Access Compliance Report

Public Rights-of-Way

Intersection ID: 6586	Main Street: ARVIN_DR	Cross Street: ATLAS_DR	Location: NW
ADA ID: E12BF986B530	Ramp Type: Perp	Initial Pass/Fail: Fail	Overall Compliance: No
		Severity Score: 8.75

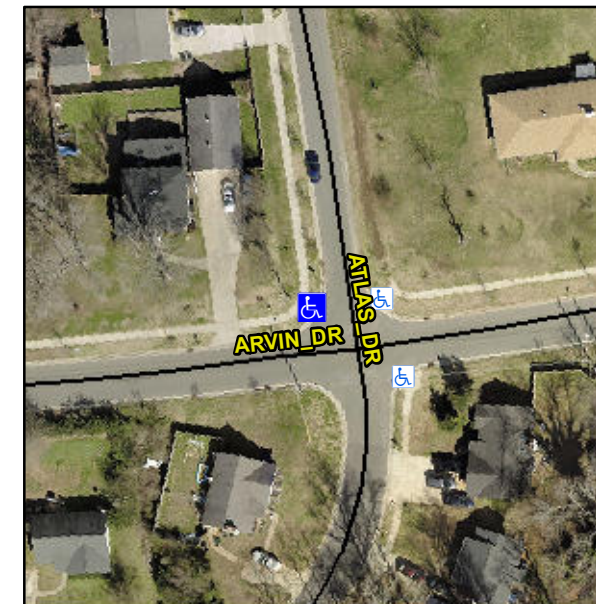
Not Found, R304.5.1

Compliance	Description	Data	Compliance	Description	Data
N/A	Ramp Length (in)	72.0	Yes	Ramp Slope (%)	7.5
No	Ramp Width (in)	47.0	Yes	Ramp XSlope (%)	2.0
N/A	Flare Type LT	N/A	N/A	Flare Type RT	N/A
N/A	Flare Slope LT (%)	N/A	N/A	Flare Slope RT (%)	N/A
N/A	Flare Traversable LT?	N/A	N/A	Flare Traversable RT?	N/A
N/A	Landing Length (in)	N/A	N/A	DWS Provided?	N/A
N/A	Landing Width (in)	N/A	N/A	DWS Contrast?	N/A
N/A	Landing Slope (%)	N/A	N/A	DWS Length (in)	N/A
N/A	Landing X Slope (%)	N/A	N/A	DWS Full Width?	N/A
N/A	Landing Curb? (Y/N)	N/A	N/A	DWS Offset (in)	N/A
N/A	Shared Landing?	N/A			
N/A	Gutter Ponding?	N/A	N/A	Gutter Slope (%)	N/A
N/A	Gutter Lip Ht (in)	N/A	N/A	Gutter X Slope (%)	N/A
N/A	Painted X Walk1?	No	N/A	Painted X Walk2?	N/A
	X Walk 1 Direction	To E		X Walk 2 Direction	N/A
N/A	X Walk 1 Width (in)	N/A	N/A	X Walk 2 Width (in)	N/A
	X Walk 1 Slope (%)	1.6		X Walk 2 Slope (%)	N/A
	X Walk 1 X Slope (%)	3.0		X Walk 2 X Slope (%)	N/A

Remove & Replace Entire Ramp.
